Technical Service Bulletin: TSB200219

Release of Thermal Recirculation Valve with Integrated Check Valve

- X15 CM2350 X114B
- X15 CM2350 X116B

Figure 1, Representation of Configuration A.

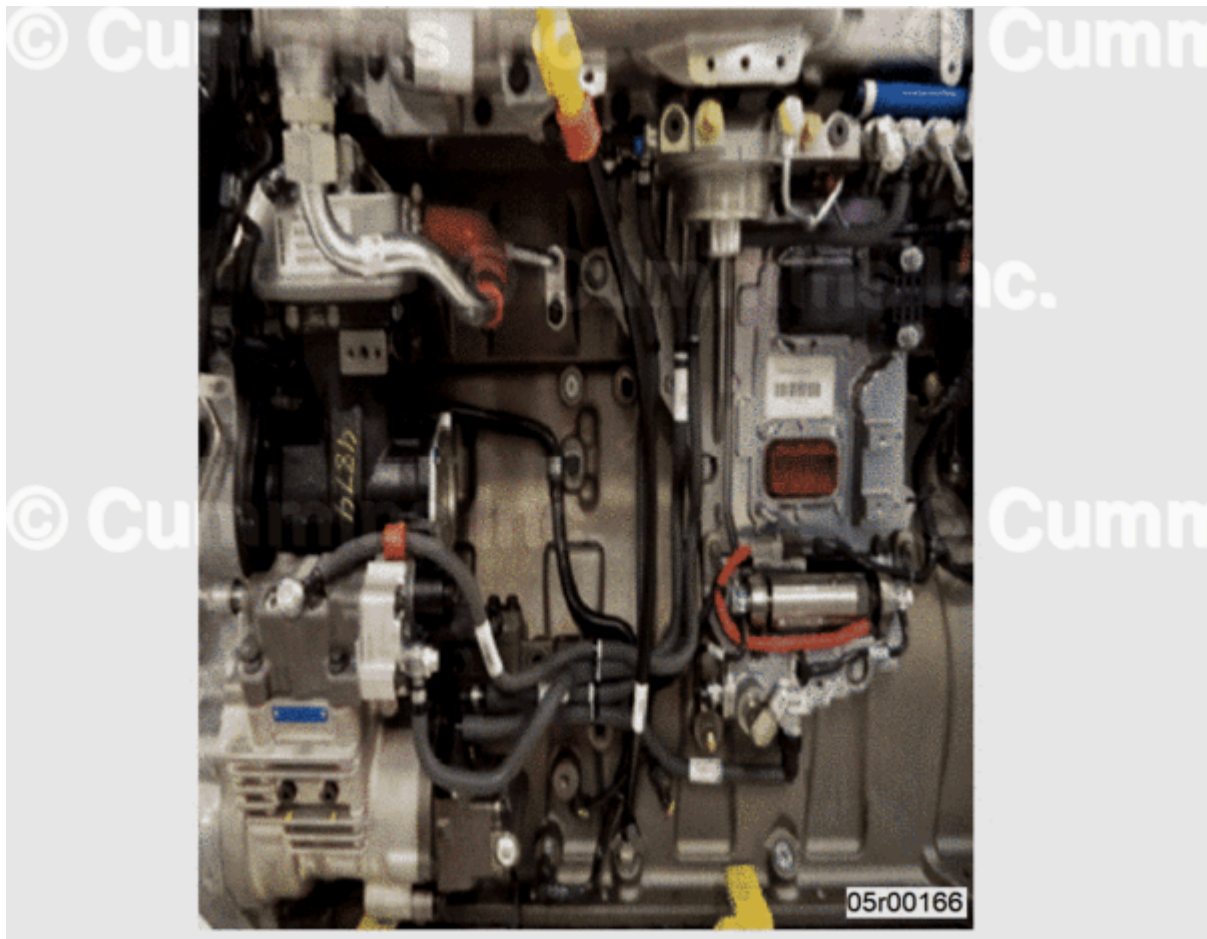
Configuration A

There may be an overlap in engine serial number (ESN). Verify the vehicle's appropriate fuel supply tube configuration and part number before commencing repairs. See Figure 1 and Figure 2 for visual confirmation and Table 2 for part number verification.

Approximate engine serial number (ESN) range for configuration A: 79890940 to 80038419. For ESN outside of this range confirm part numbers from Table 2.

No service kit is available for this configuration.
